TO: Members of the MAG Specifications and Details Committee

SUBJECT: MEETING NOTIFICATION AND TRANSMITTAL OF AGENDA

MEETING MINUTES FROM THE
MARICOPA ASSOCIATION OF GOVERNMENTS
STANDARD SPECIFICATIONS AND DETAILS COMMITTEE

February 6, 2008

DETAIL NO.
535-2

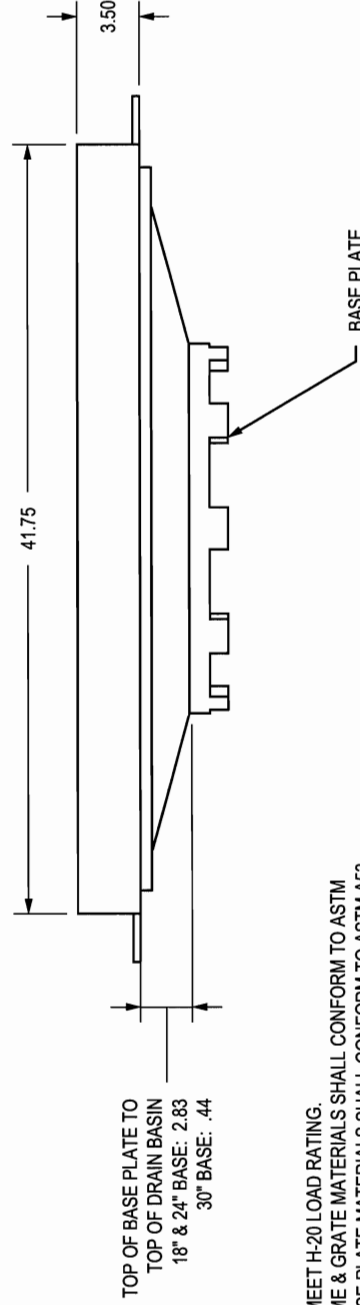
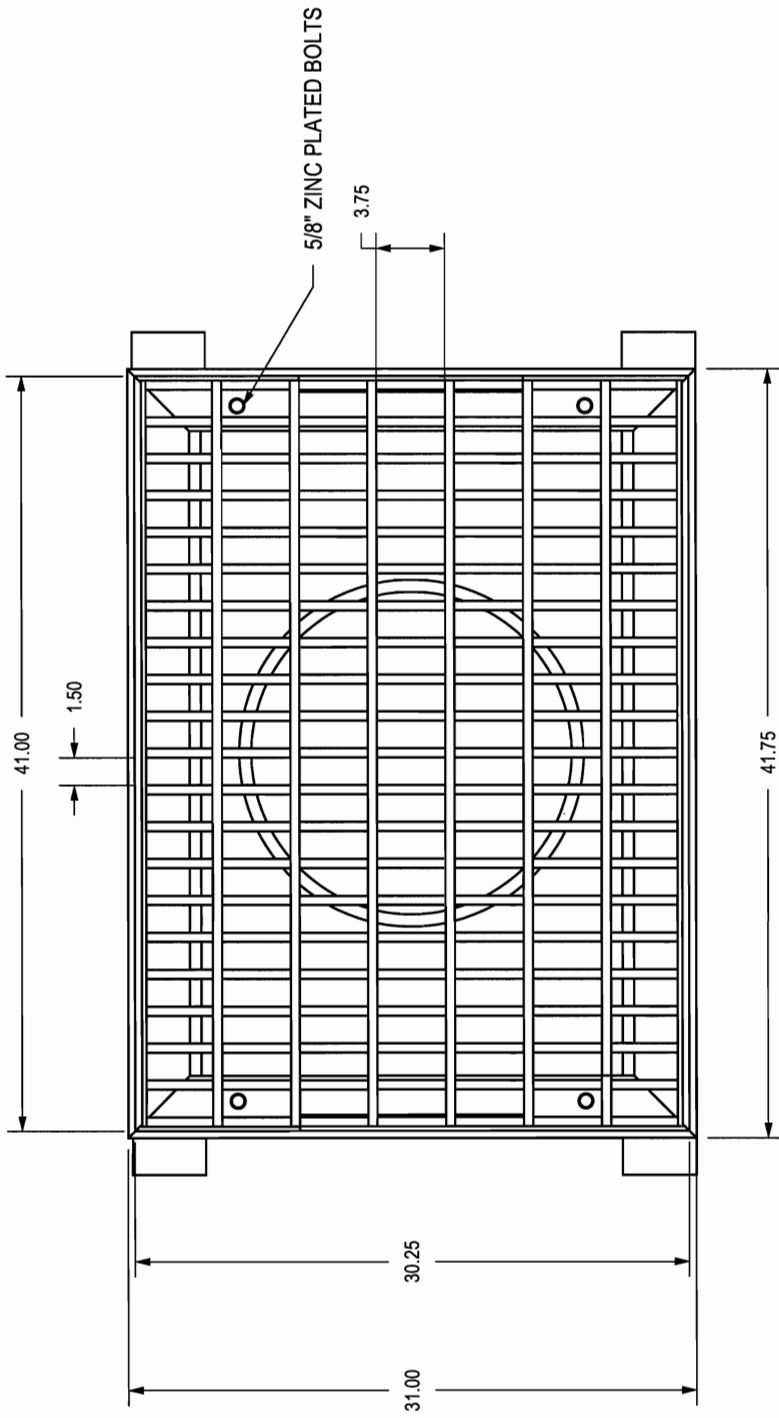
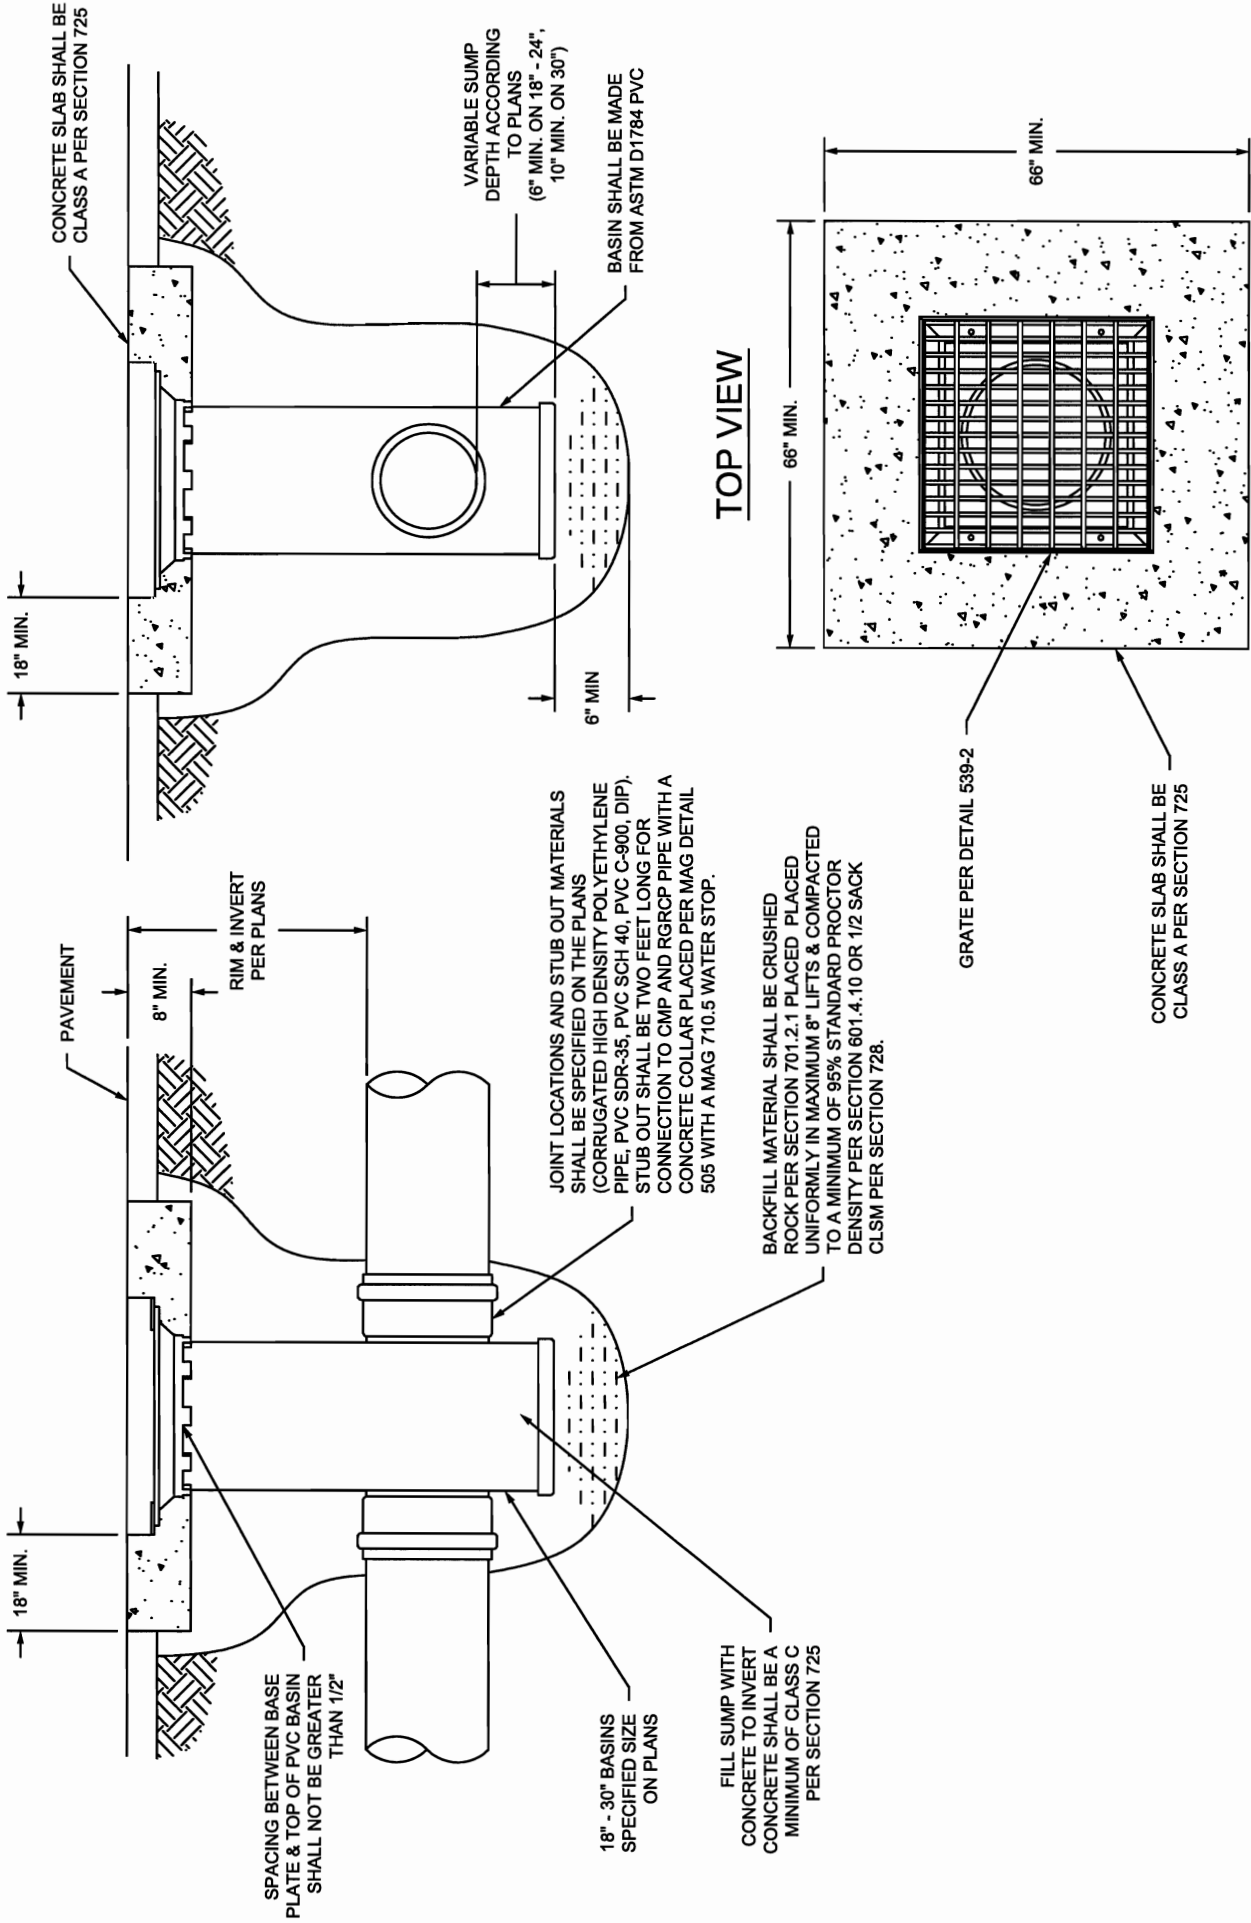
b. **Case 07-03A – PVC Catch Basins, Proposed New Details 535-2, 535-3, & 537-2. Case 07-03B – Inlet Structures, Proposed New Details 539-2, 542-1 through 4 & 543-1 through 5:** Details to allow the use of PVC catch basins and inlet structures. Peter Kandarlis provided written comments that summarized a number of changes recommended during previous meetings. Committee members discussed these comments and also recommended including dimensioning and slopes on catch basin concrete slabs, including a water stop when referencing MAG Detail 505, specifying pipe class for basins materials, including a note referencing invert elevations per project plans, and including the word “shall” for the first note on details that reference required load ratings. Dale Phelan will prepare revisions addressing comments and discussion items for the next meeting.

1. GRATE SHALL MEET H-20 LOAD RATING.
2. QUALITY: FRAME & GRATE MATERIALS SHALL CONFORM TO ASTM A-36 STEEL. BASE PLATE MATERIALS SHALL CONFORM TO ASTM A53 GRADE 70-50-05 DUCTILE IRON
3. ALL STRUCTURAL STEEL TO BE PAINTED ONE SHOP COAT OF NO. 1 PAINT AND TWO FIELD COATS OF NO. 10 PAINT AS PER SECT. 790.
4. ALL WELDS ON FRAME AND SIDE BARS ON GRATE SHALL BE FULL LENGTH OF JOINT.
5. APPROX. DRAIN AREA = 761.18 SQ IN.

SECTION 615

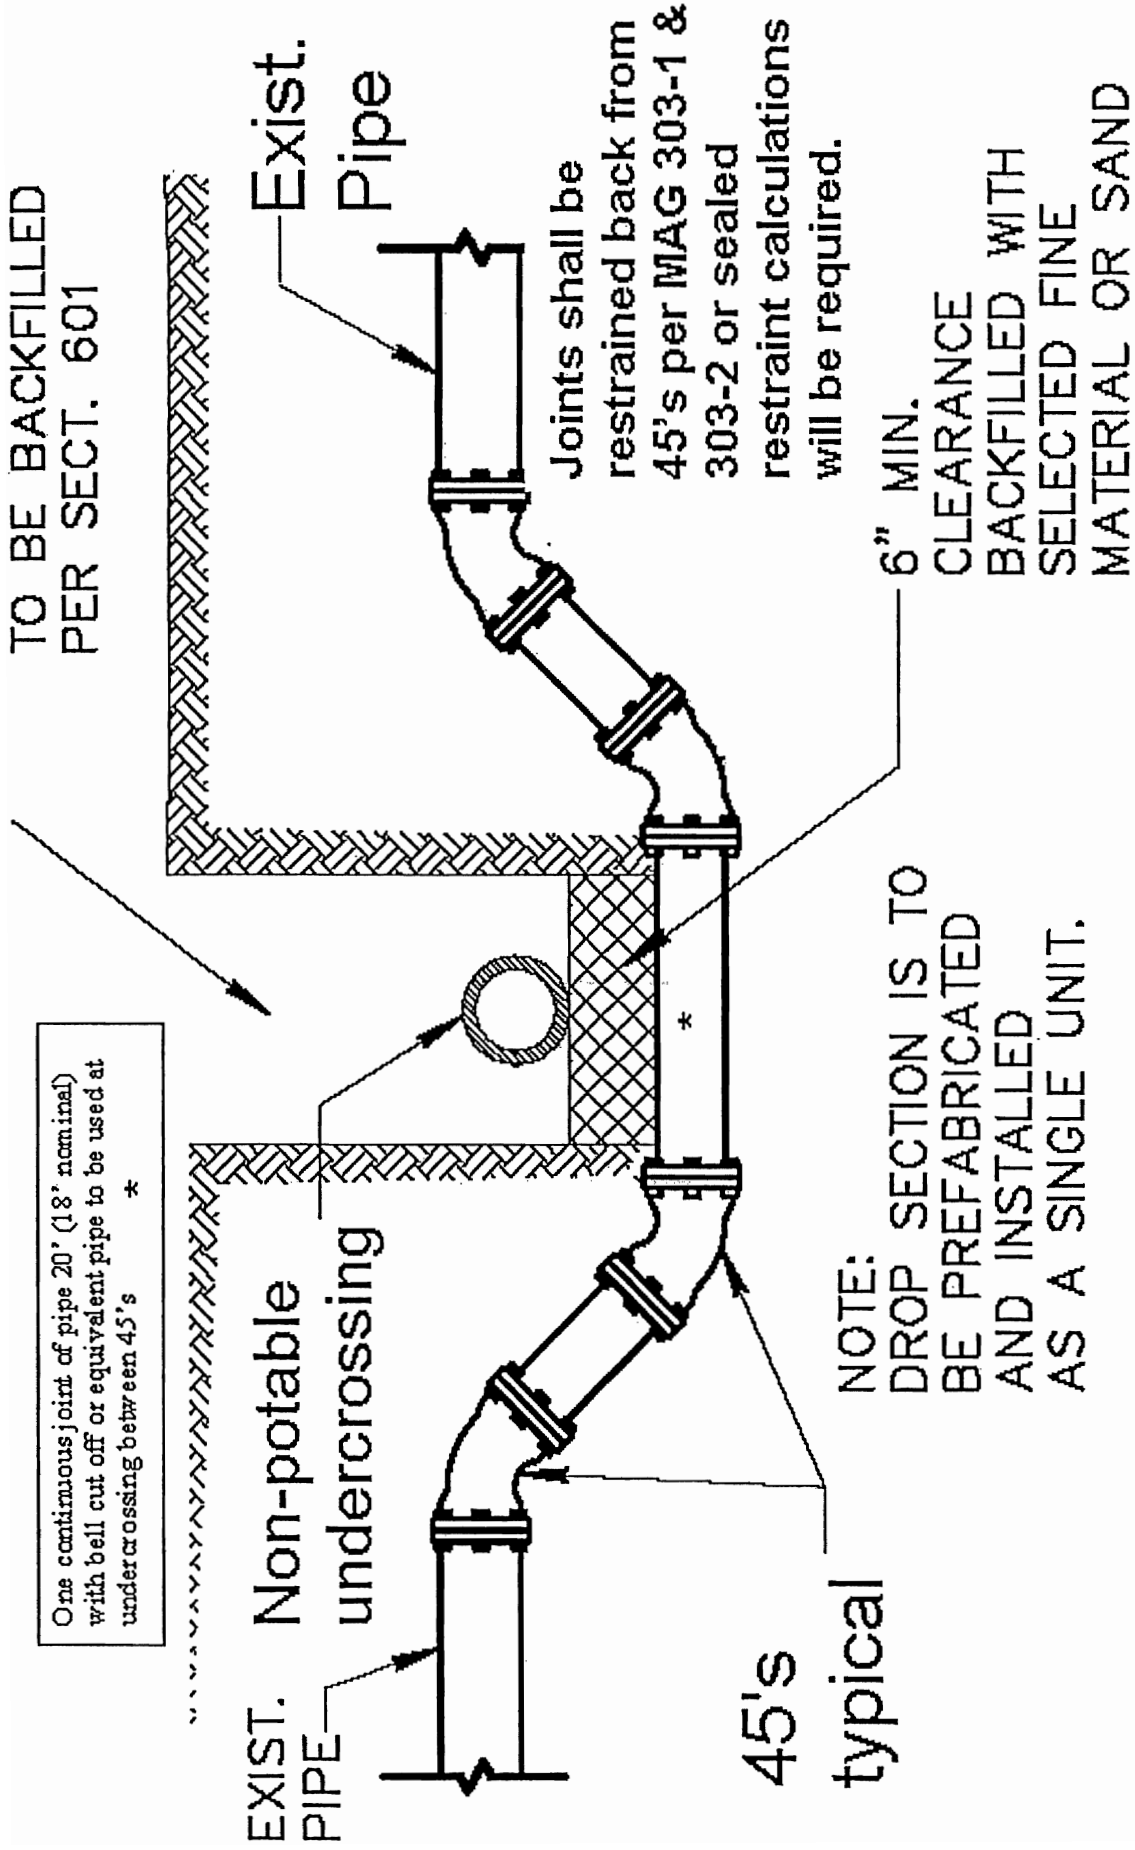
c. **Case 07-08 – Revision to Section 615.2, Sewer Line Construction:** Provide water ponding tolerances inside sewer pipe. Gordon Haws recommended keeping trenching tolerances in the existing section and adding tolerances for video inspection. Paul Nebeker identified the need for video measurement calibration standards. It was agreed that the various methods and equipment used by video firms should be examined before final establishment of tolerances and requirements. Jami Erickson requested revisions include the option for agencies to perform video tests and noted that the City of Phoenix has less stringent tolerances than those proposed. She will provide the committee with COP standards and tolerances. Bob Herz will contact Gerald Wright of Queen Creek to determine his status with the committee so that the case can move forward.

(D) Closed Circuit T.V. Inspection:

The Contracting Agency reserves the right to visually inspect the interior of the sewer line using a television camera. Any defects in the pipe or construction methods revealed shall be corrected by the Contractor at no additional cost to the Contracting Agency.

370

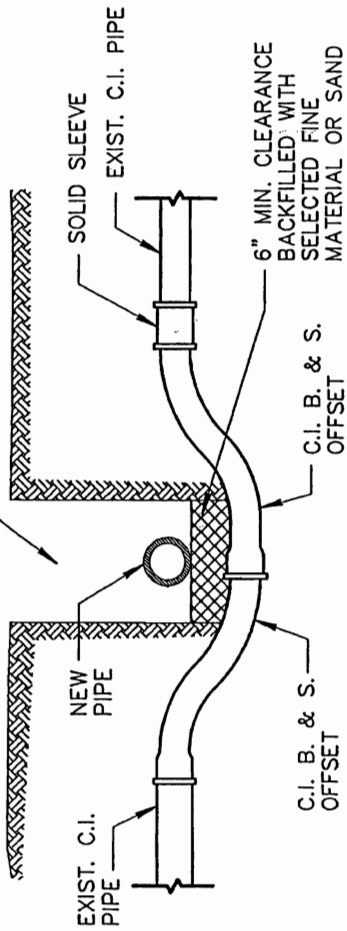
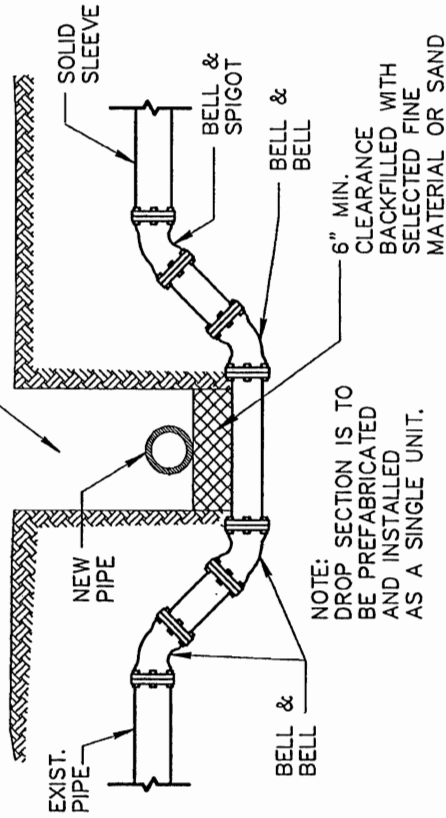
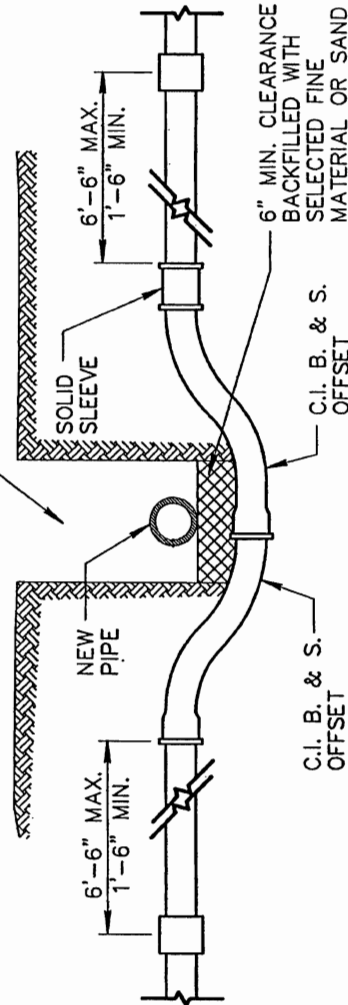
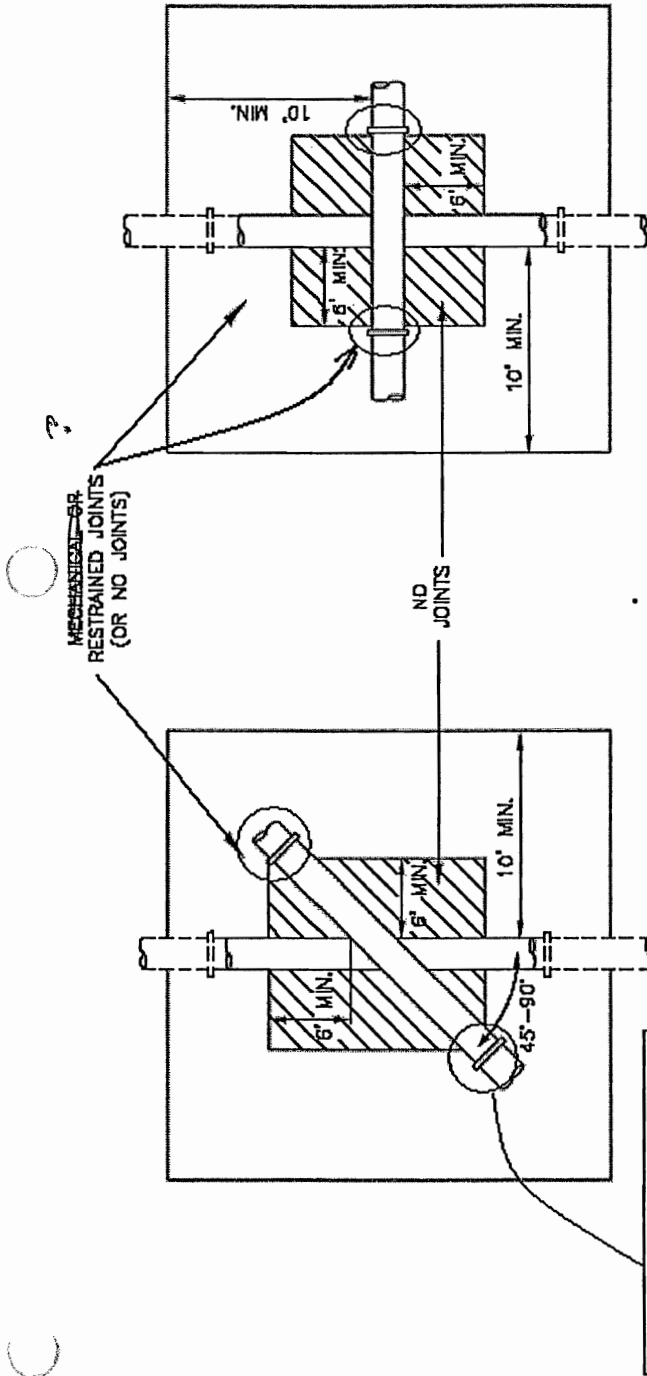
d. **Case 07-11 – Revision to Detail 370, Vertical Realignment of Water Mains:** Include an option for realignment of ductile iron mechanical joint. The committee had no discussion on this item.

DETAIL NO. <i>180-1</i>	APPROVED BY: <i>Mariopg Association of Governments</i>	FILL PIPE DETAILS FOR PORTABLE TANKS WITH AIR GAP SEPARATION	DETAIL NO.
----------------------------	---	--	------------

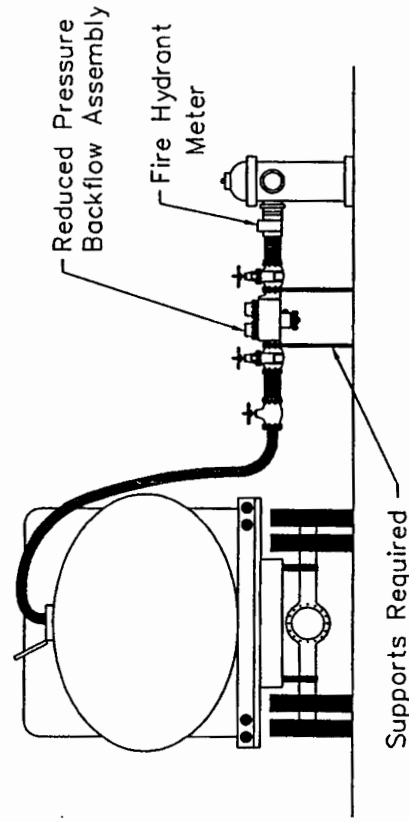
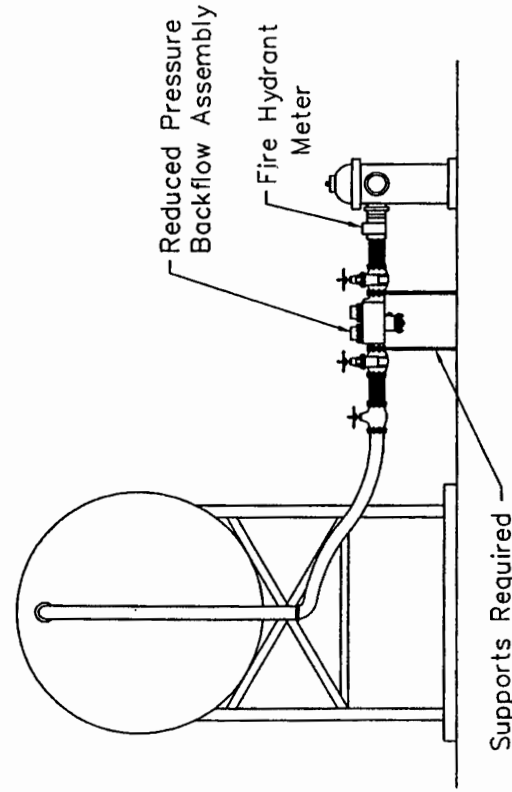
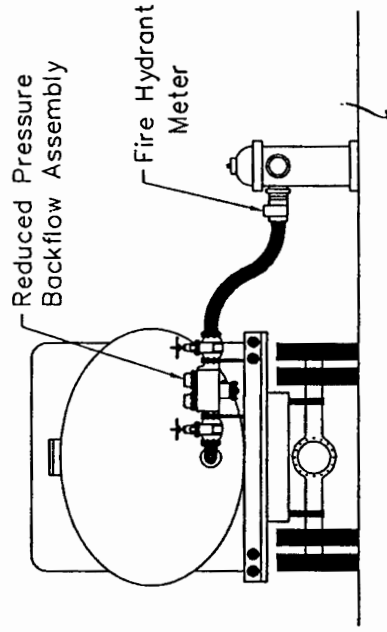
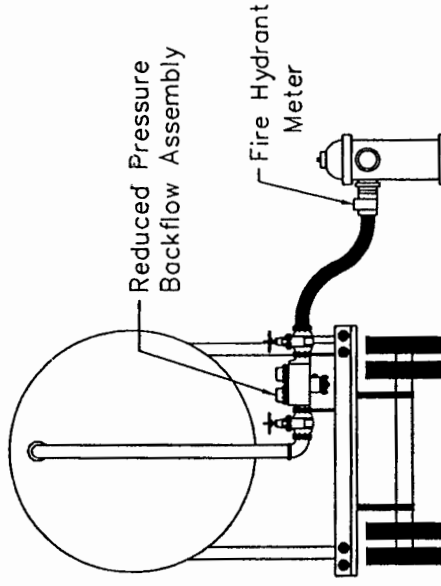
One such standard detail that is currently not included in the MAG Standard Specifications and Details is one for a fill pipe detail for portable tanks with or without air gap separation. The current municipal details by City of Chandler, City of Goodyear, City of Mesa, and City of Scottsdale can be deleted and added as one two (2) page detail in the 100 Series of the MAG Standard Details section.

NOTE: Reduced Backflow Device Per Agency Requirement
